Helios EN010140

Expanding from my published submission, 28 February 2025. Updated 18/03/2025 with Questions.

The Battery Energy Storage System (BESS) plus the 132Kv Sub Station

Drawing Title:
**Figure 3.5
Inverter Stations**

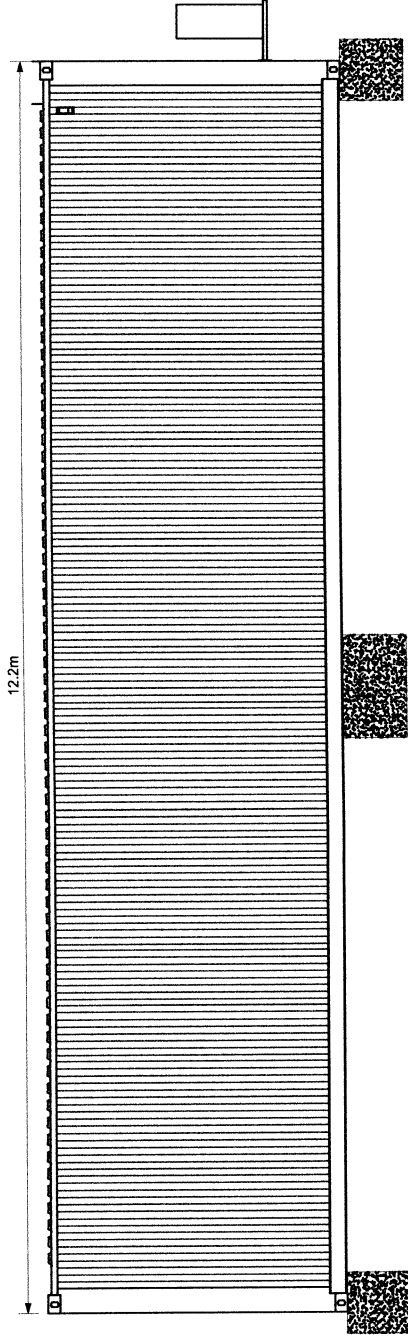
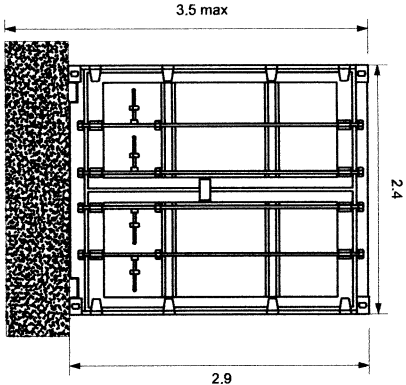
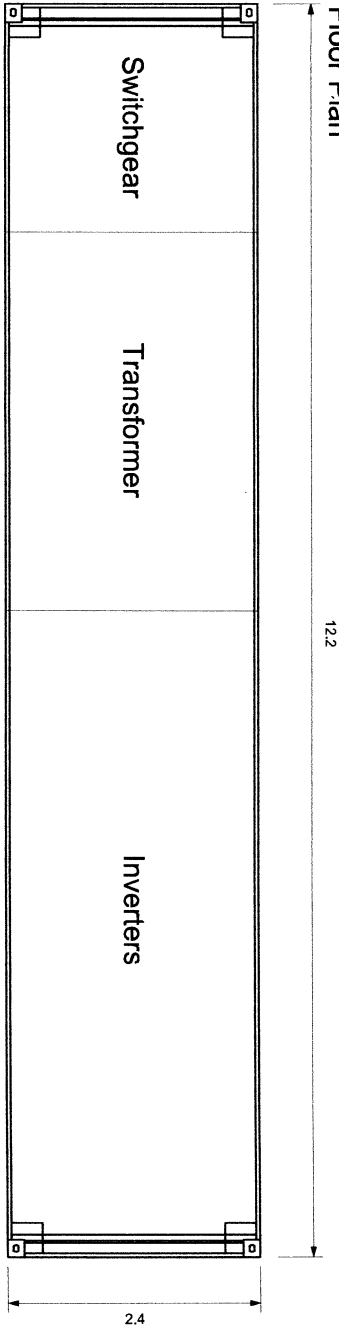
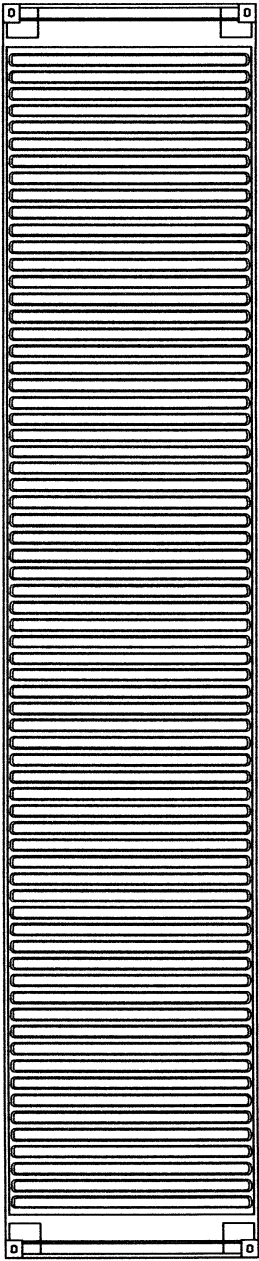
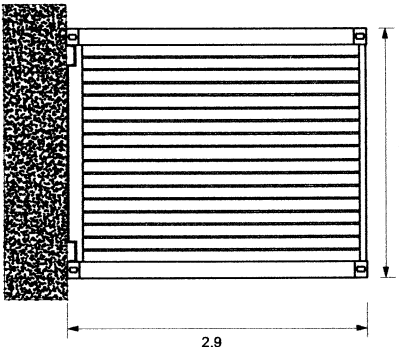
3.4.17 The Field Stations, (see attachments)

2. Are these the Inverter Stations? (if so GUARRANTEED NOISE) up to 100?

3. Where are the, to scale location drawings for these?

Figure 3.7
BESS Battery Container
Elevations

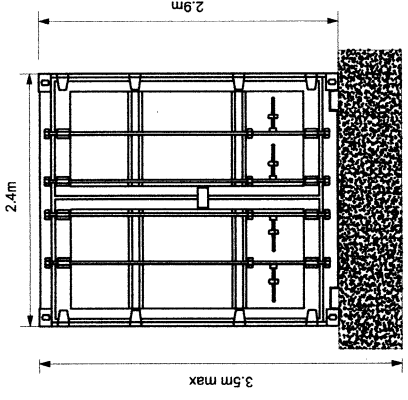
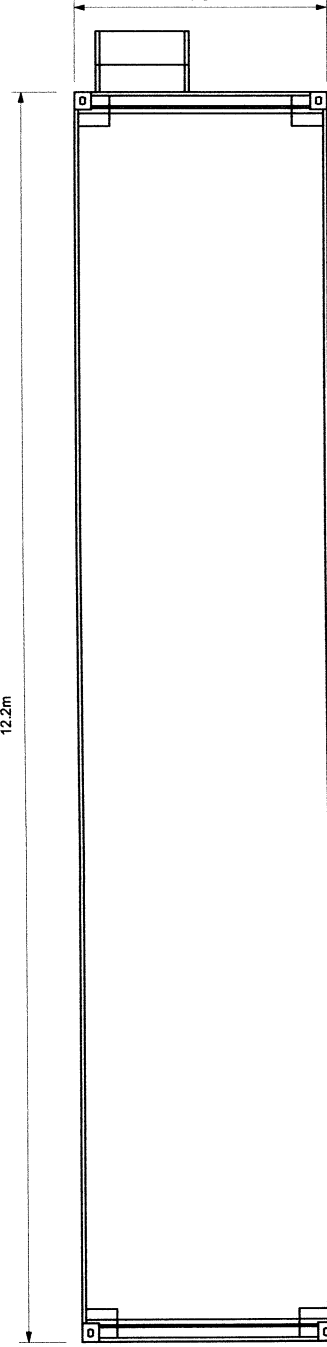
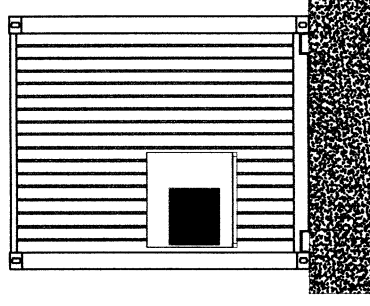
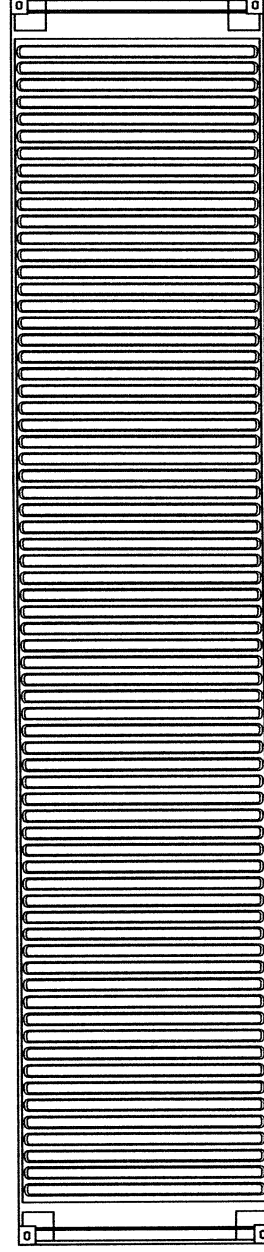
- **Battery containers** of up to 12.2m in length x 2.4m in width x 3.5m in height, including concrete supports 600mm in height (refer to **Figure 3.7 BESS Battery Container Elevations [EN010140/APP/6.2.3.7]**); **HOW MANY?**

BESS and Substation Preliminary Drainage Strategy

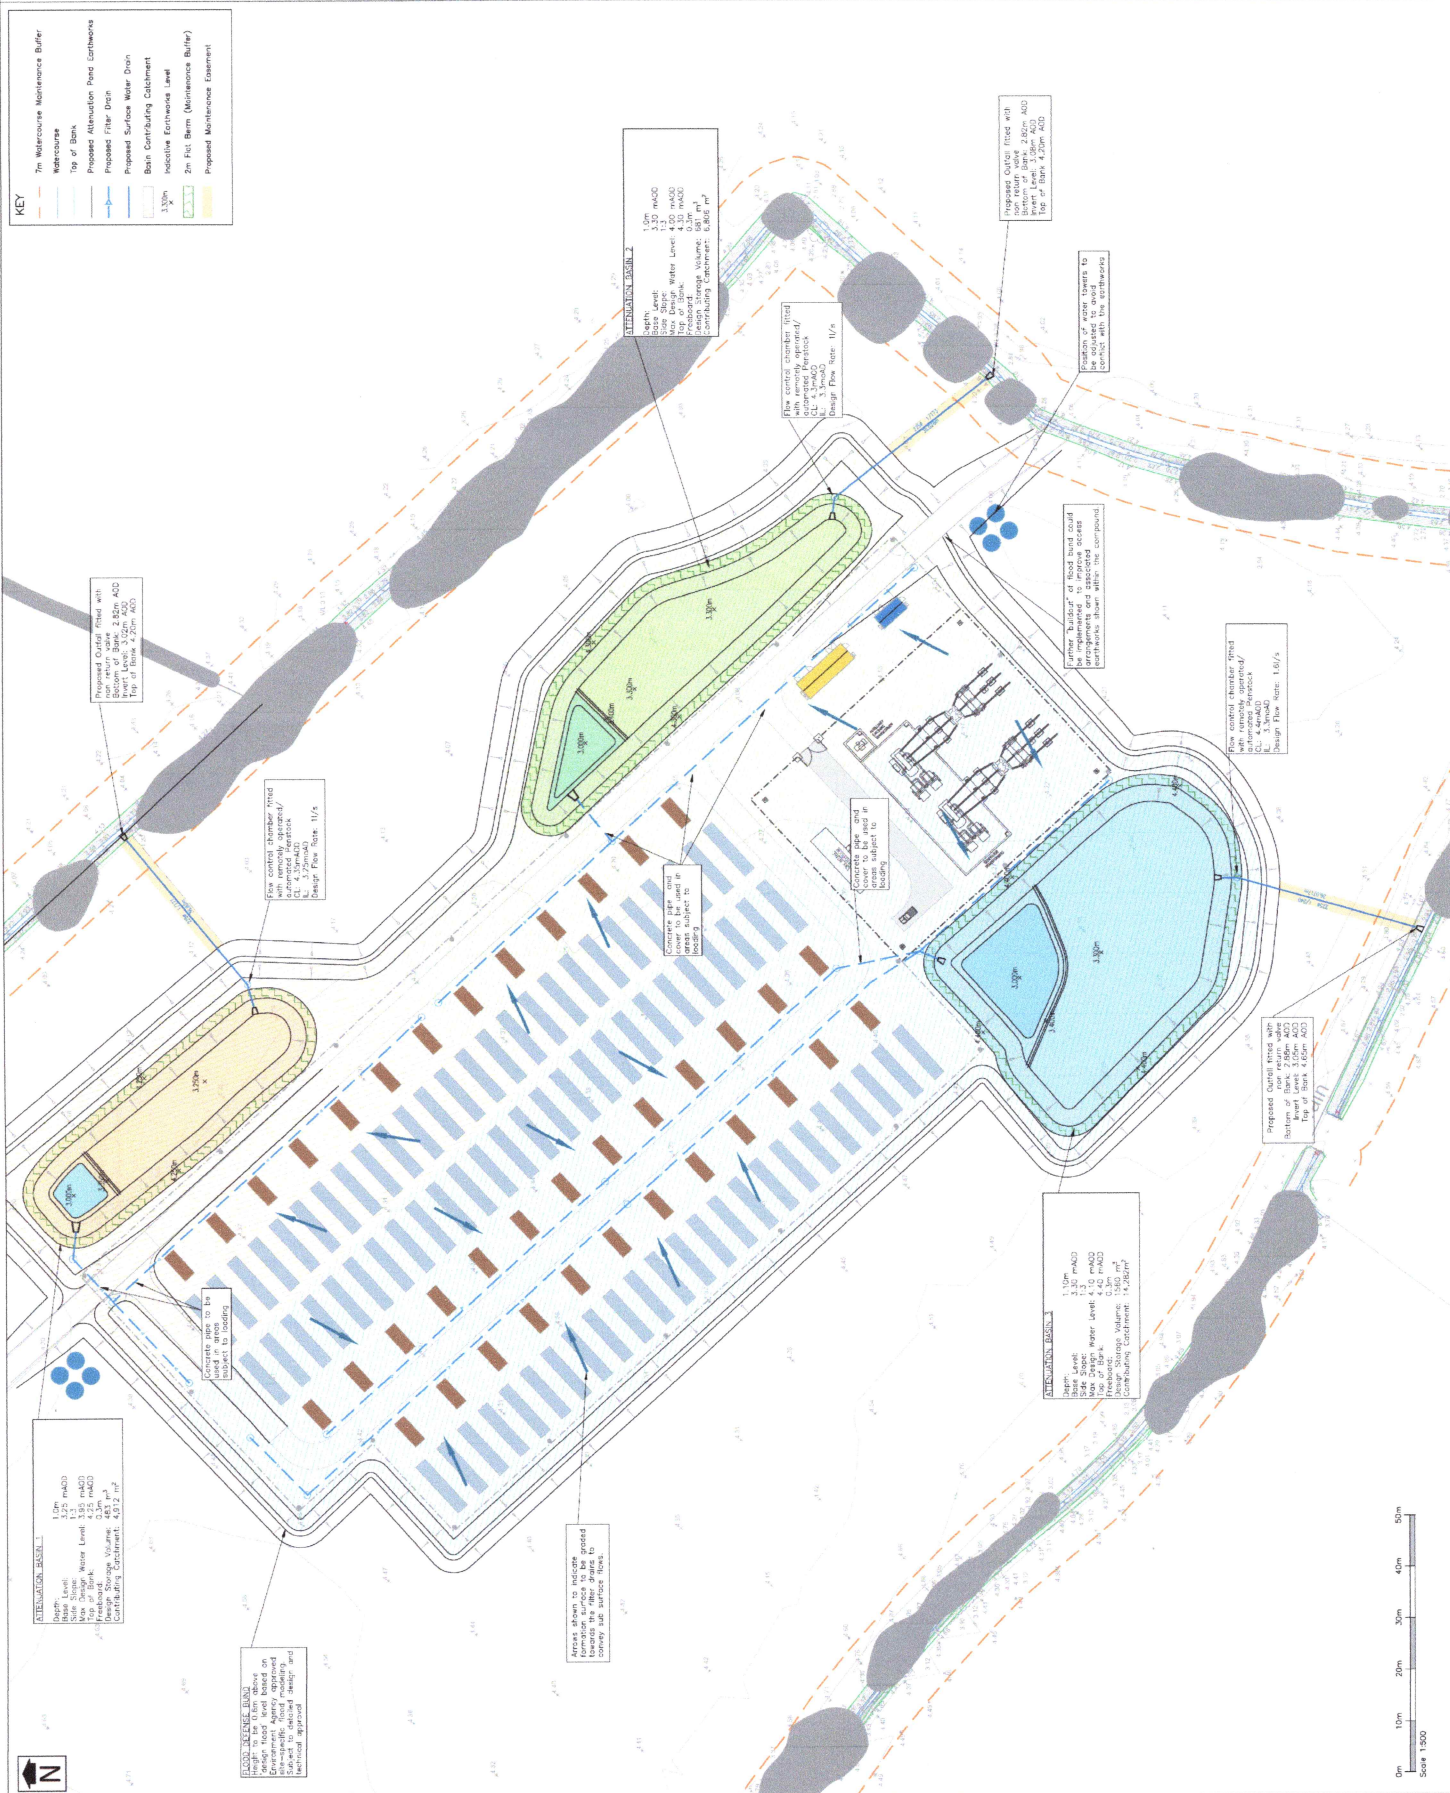
5. looking at **BESS and Substation** Preliminary Drainage Strategy Drawing. Fig 4.3

Are the 76 large containers - the Battery containers?

6. What are the 38 smaller brown containers?

FIG 7.19

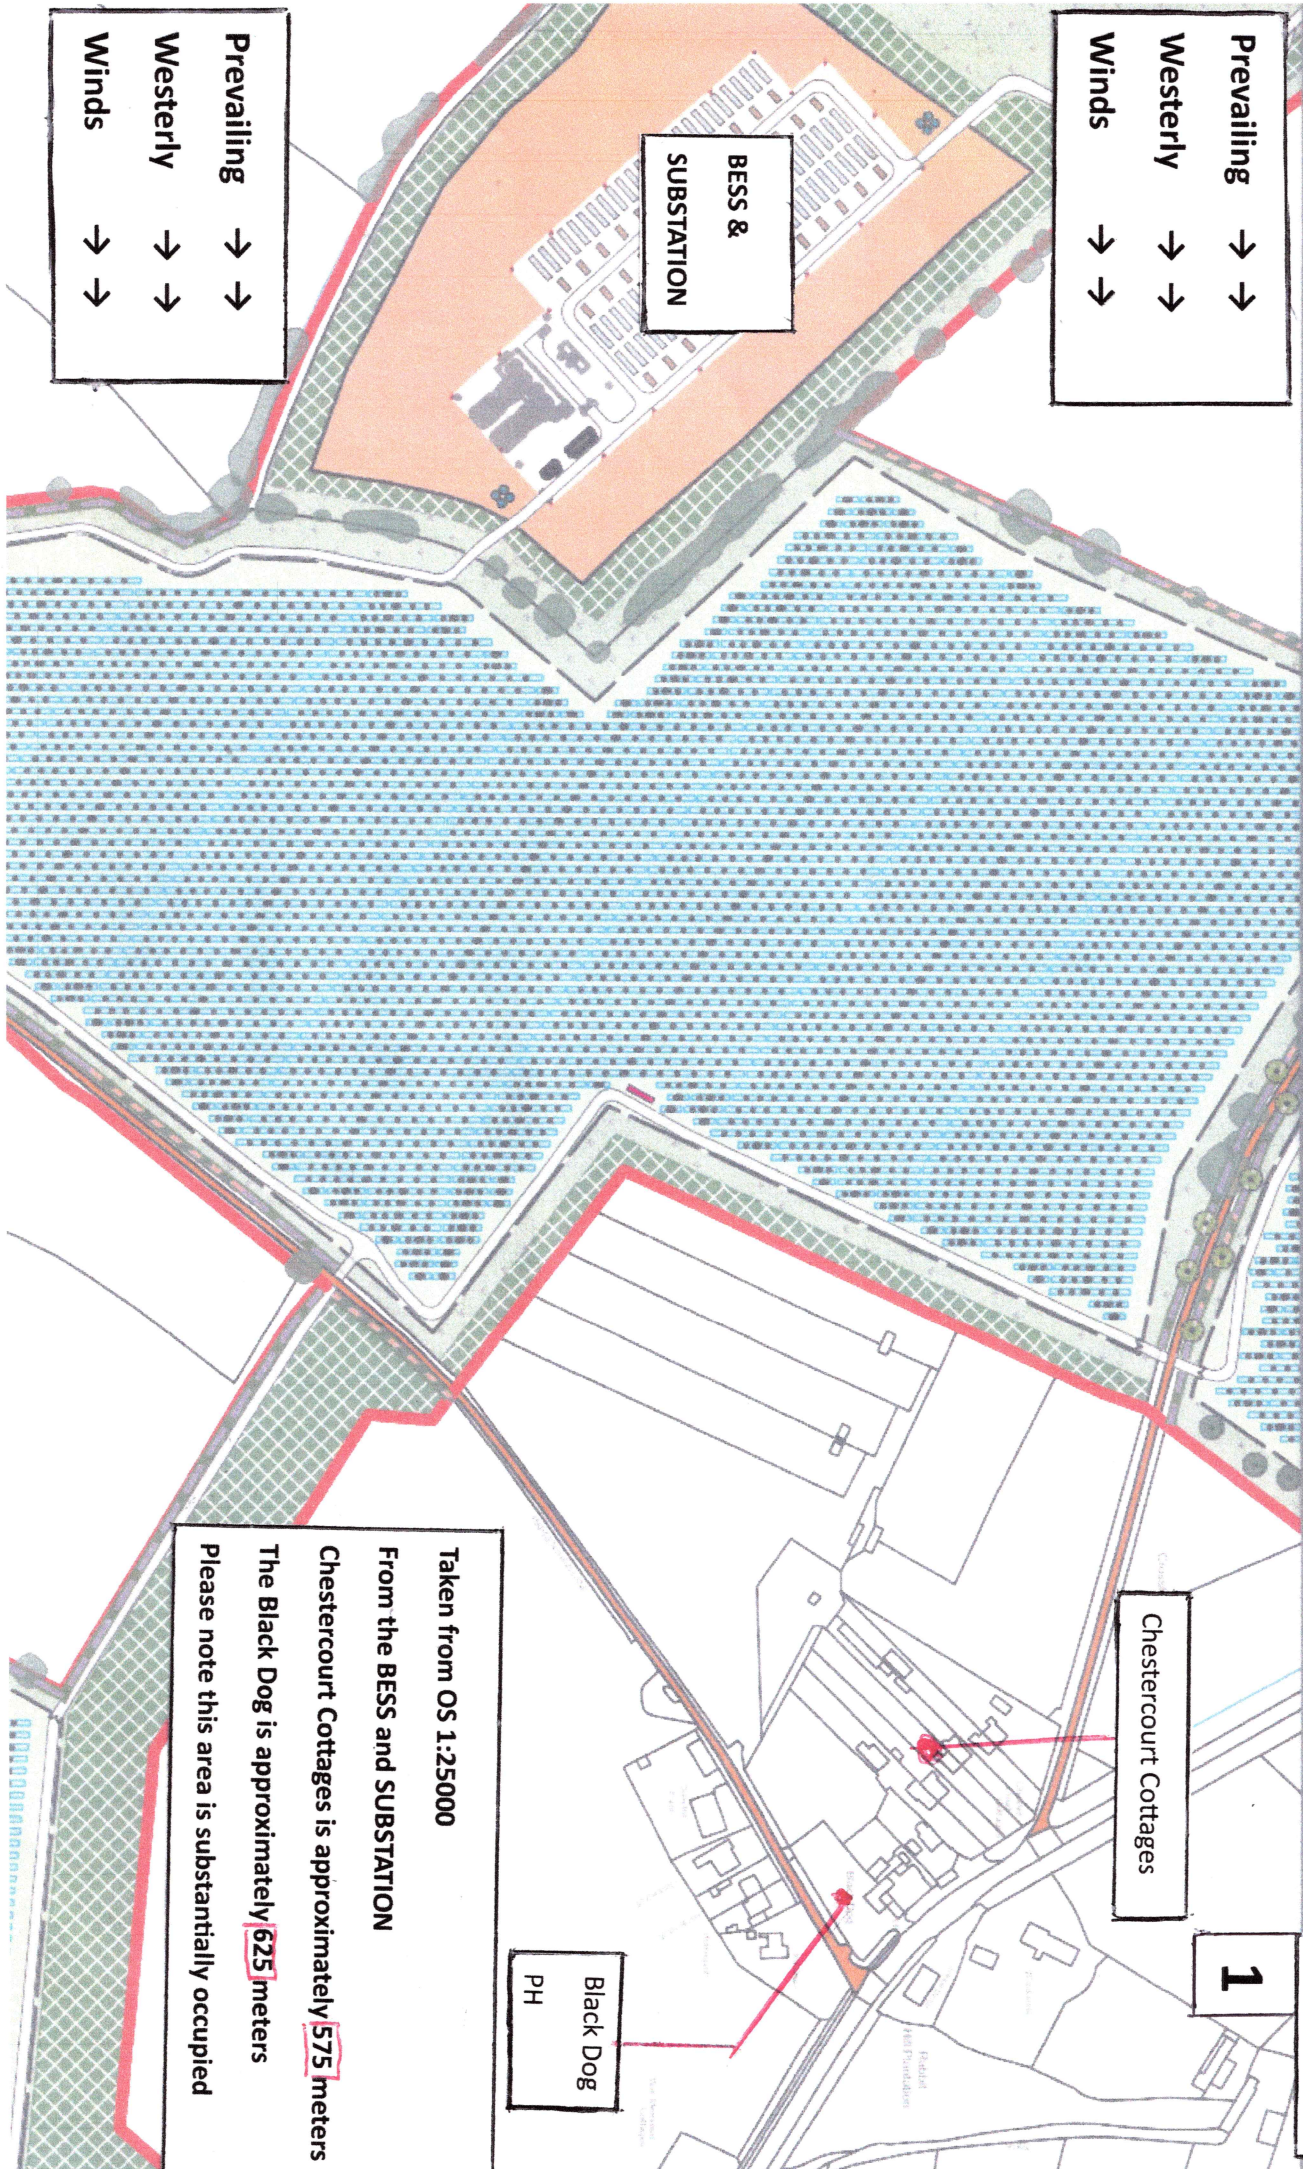
Taken from OS 1:25000
From the BESS and SUBSTATION
Chestercourt Cottages is approximately **575 meters**
The Black Dog is approximately **625 meters**
Please note this area is substantially occupied

EN010140-000271-6.2 Environmental Statement Figure 11.4 - Noise Contour Map Daytime.

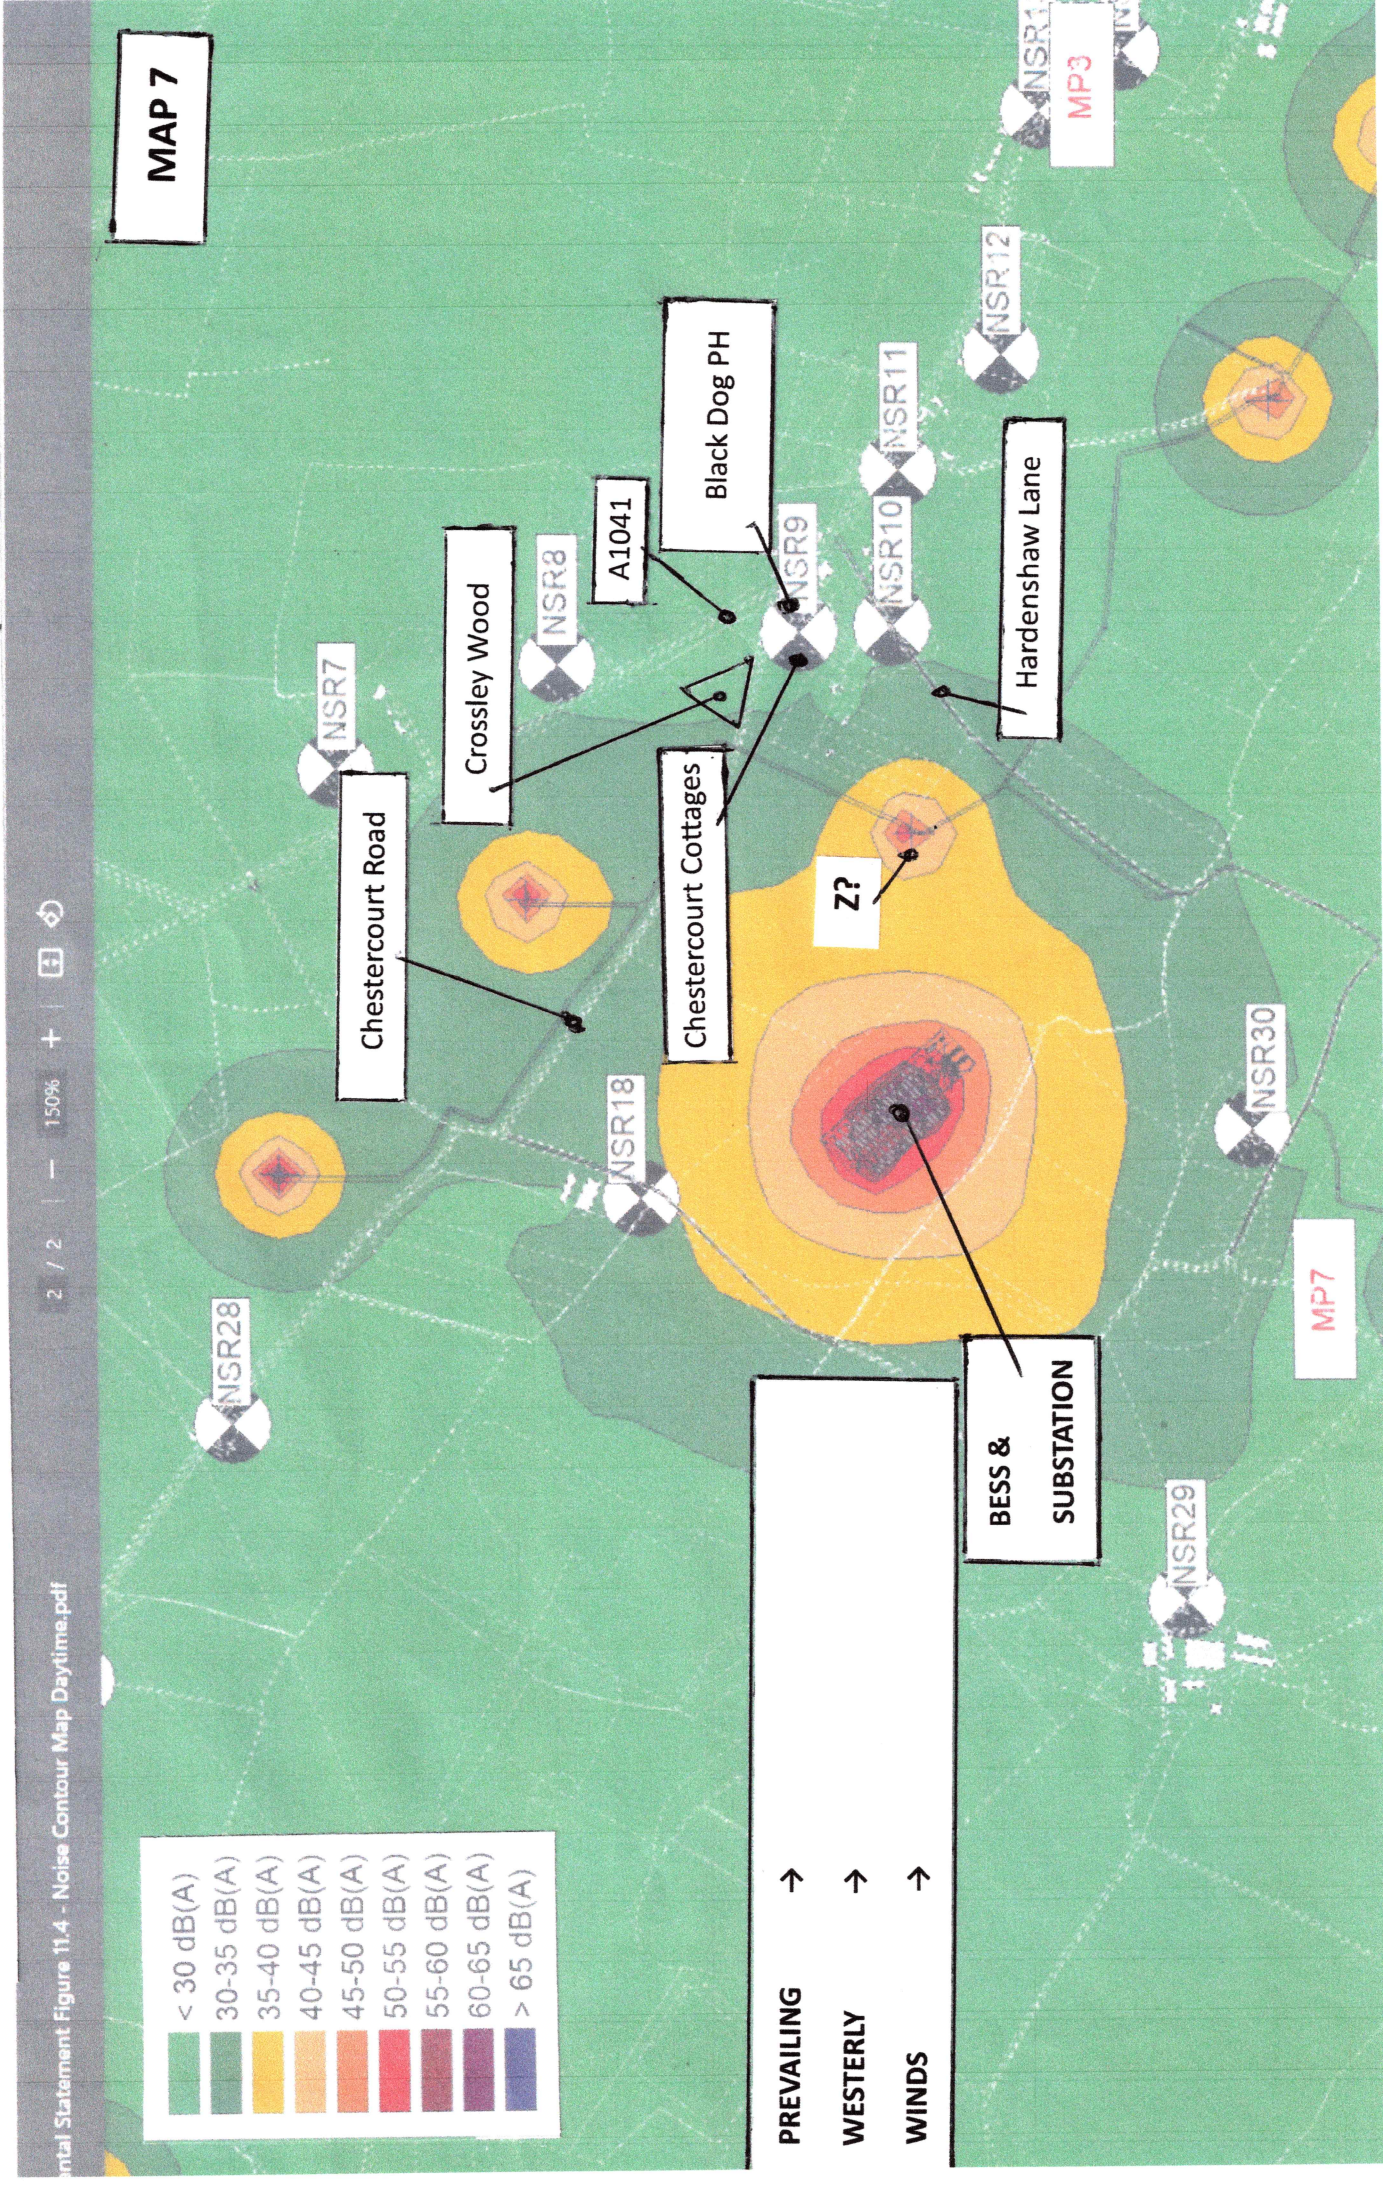
With Reference to Environmental statement Figure 11.4

(The map I have supplied number 7), has a symbol Z? which I have added. Whatever it/they are. (counted 28) They have the capability of emitting 45-50 dB of noise. The Z? in question is ALMOST AT THE BOTTOM OF MY GARDEN.

1.a What are these?

On the poorly detailed Map Fig 11.4 – Noise Contour Map Daytime, (my ID Map 7). I would like some independent assurance, that *as if by some miracle*, we are in the < 30 dB zone.
